# ***ETHERIDGE SHIRE COUNCIL***

## **RE: UPDATED KIDSTON SOLAR PROJECT DESIGN DRAWINGS**

Reference is made to your email dated 01 November 2016 and attached amended site layout for the Kidston Solar Farm Project (Ref: UGL Drawing Number: TC-10075-DP1-015 Amdt D). (see Attachment 1) requesting confirmation from council that the new proposed sit layout remains in conformance with the original Decision Notice.

ATTACHMENT 1:

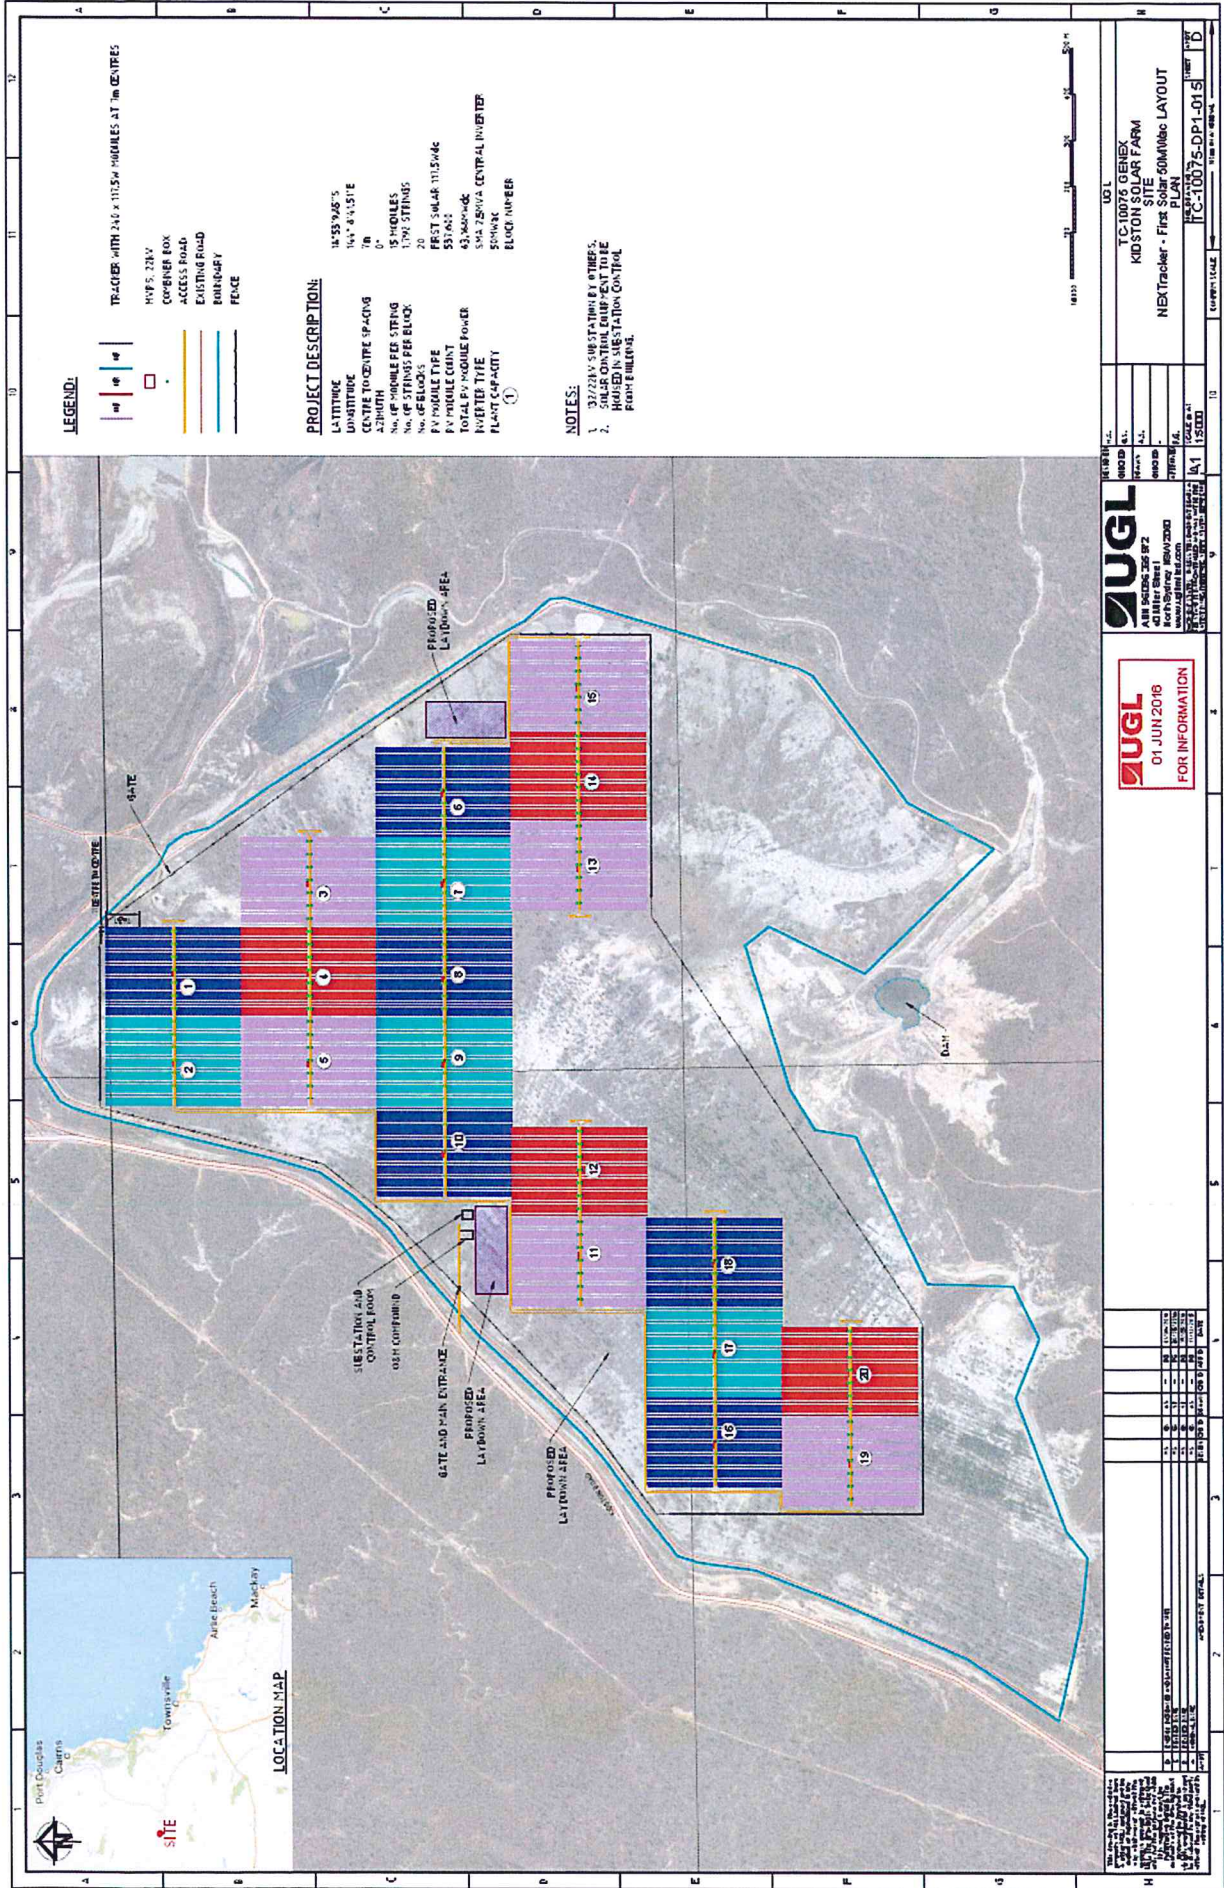
Generally it is noted that the site coverage as shown on the amended drawing would indicate a minimal reduction in site coverage from that shown on originally submitted plans being Aecom: Project Number 60432033 – Sheet Number 00-EL-1011A. (see Attachment 2)

The Etheridge Shire Council can confirm that the amended general site layout as detailed on the above plan does remain in conformance with the original Decision Notice and in particular Condition 1 of that decision.

As previously discussed it is noted that the amended plan does not show the route of the proposed 132kV overhead line from your newly located substation to the existing Ergon substation.

Council seeks your confirmation on the location of this overhead line linking the two substations ensuring its location remains wholly within the boundaries of your land.
